COUNCIL SUPPLEMENTARY ASSESSMENT REPORT
WESTERN REGIONAL PLANNING PANEL

PANEL REFERENCE & DA NUMBER	PPSWES-123 – DA170/2022
PROPOSAL	5MW Electricity Generating Works and Associated Infrastructure
ADDRESS	Lot 286 DP756894, Lot 90 and 91 DP756897 33 Blain Road, CAERLEON
APPLICANT/OWNER	Simon Jones C/-Mid-Western Regional Council Owner: Mid-Western Regional Council
DATE OF LODGEMENT	11 November 2021
APPLICATION TYPE	Development Application
REGIONALLY SIGNIFICANT CRITERIA	Clause 3, Schedule 6 of <i>State Environmental Planning Policy (Planning Systems) 2021</i> : <i>Council development with a capital investment value exceeding \$5,000,000.</i>
CIV	\$6,810,900 (excluding GST)
CLAUSE 4.6 REQUESTS	Not applicable
KEY SEPP/LEP	<ul style="list-style-type: none"> • State Environmental Planning Policy (Biodiversity and Conservation) 2021 • State Environmental Planning Policy (Planning Systems) 2021 • State Environmental Planning Policy (Resilience and Hazards) 2021 • State Environmental Planning Policy (Transport and Infrastructure) 2021 • Mid Western Regional Local Environmental Plan 2012

SUPPLEMENTARY ASSESSMENT

Figure 2 – Glare Summary

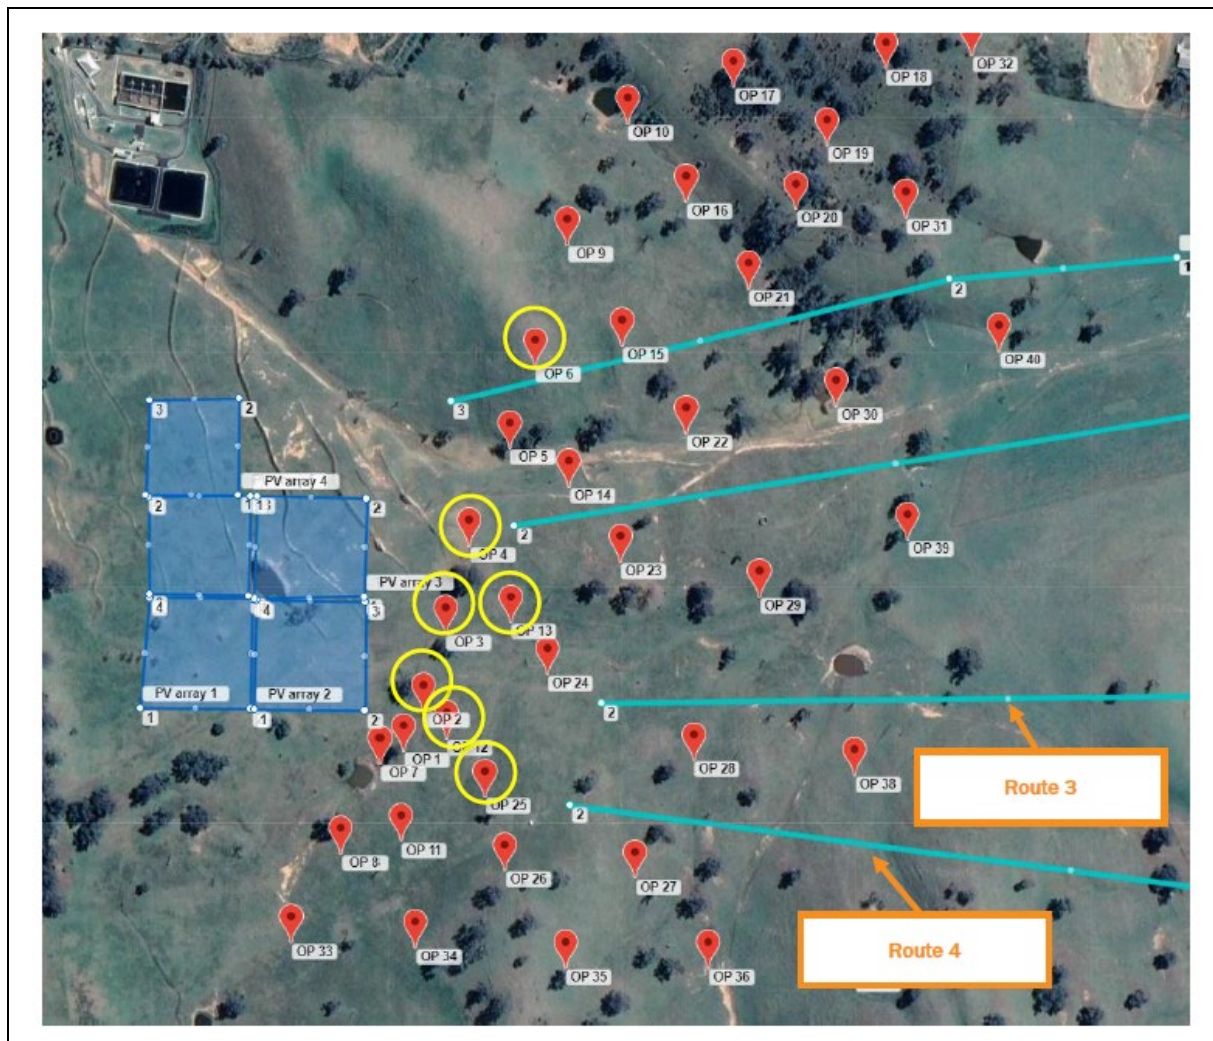
Comment: The applicant has provided an analysis which has included many assumptions based on various observer points and roads for the ‘future’ development of the Caerleon Estate along with five (5) ‘backtracking’ configurations for the development, as this has not been determined at this stage.

The summary below is provided for each backtracking configuration option and the potential receptor locations (table 4 and figure 7 from the report). It is important to note that these findings are based on existing conditions of the site and do not accommodate any proposed landscaping treatment.

Figure 4 – Site Location Map including Sewer Treatment Buffer

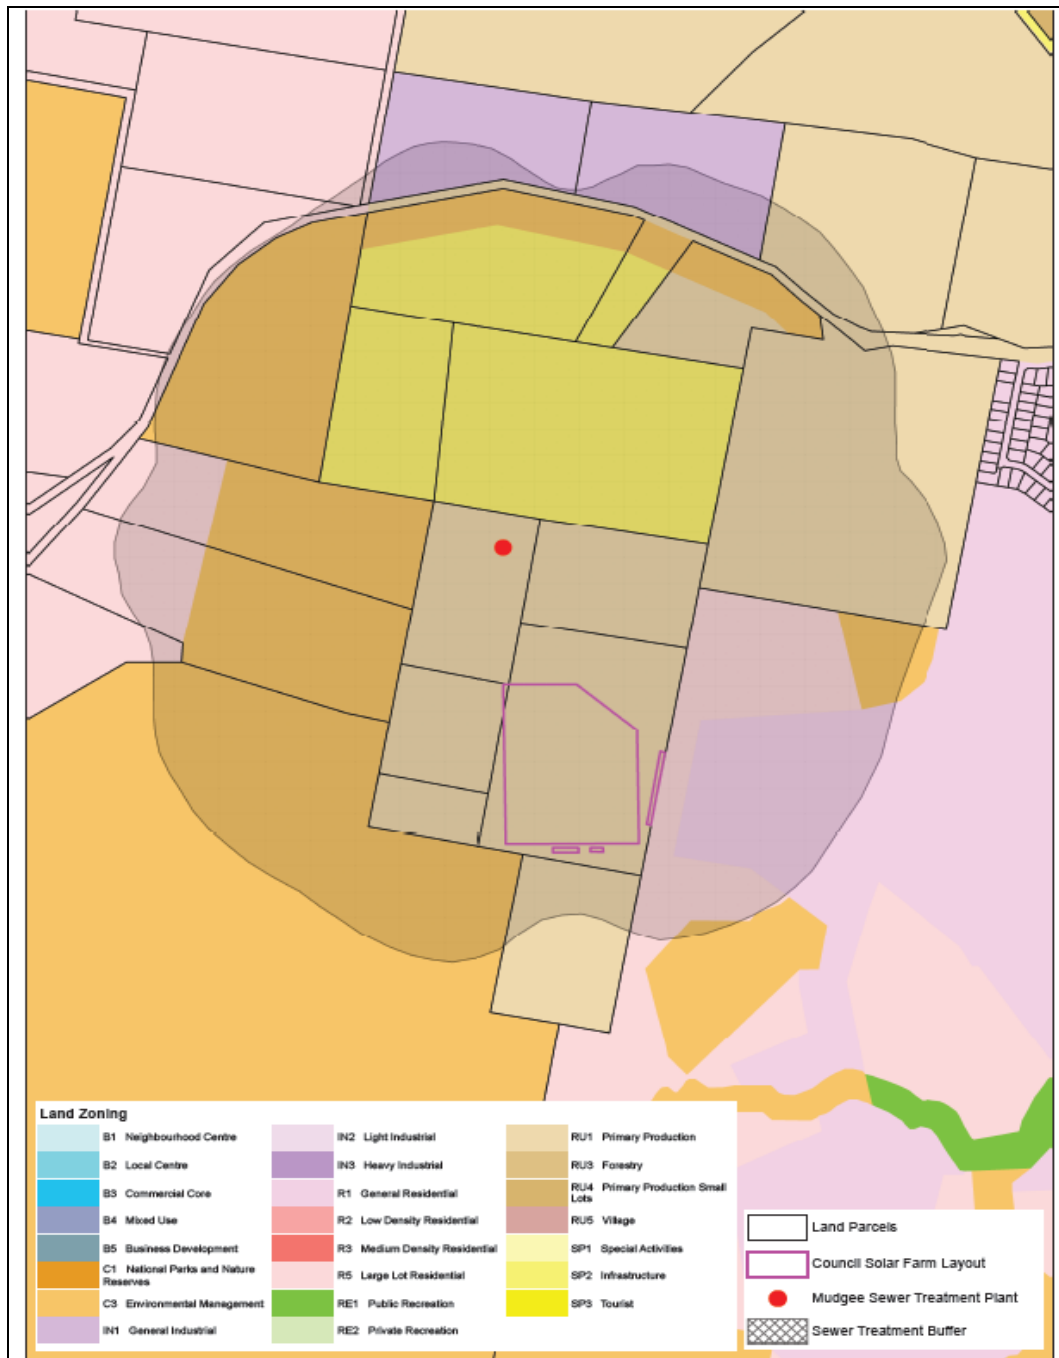
Further to the above, the assessment does not accommodate the existing sewerage treatment buffer that extends over the majority of the observer points selected in the assessment. Clause 6.12 of the Mid Western Regional Local Environmental Plan results in the need to protect the sewerage treatment plant operations located on the northern portion of the solar farm site and would ultimately constrain the future development of this area of Caerleon Estate for residential purposes – see Figure 4 below.

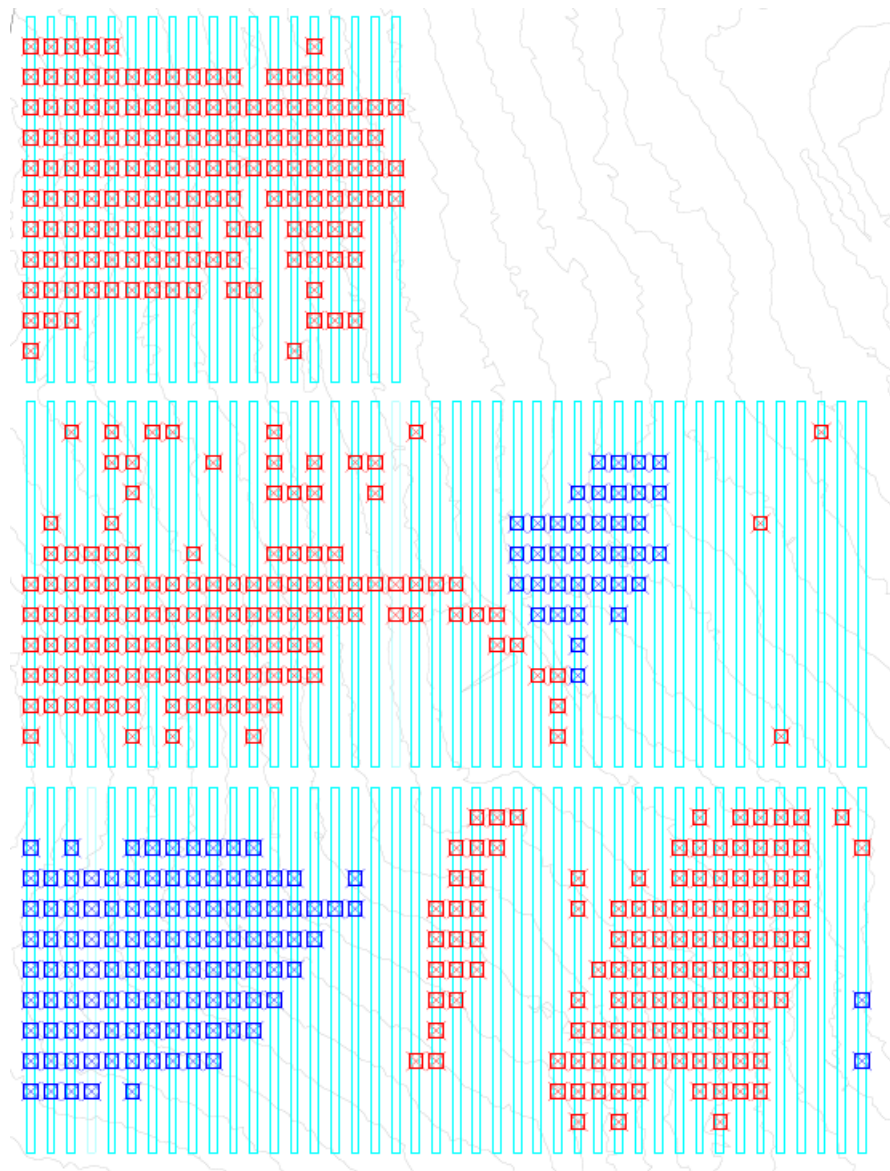
The drawing below shows in red the areas required to be cut and in blue the areas required to be filled as part of the general smoothing of the site.

This is a preliminary assessment only based on the layout, topography file and tracker heights required.
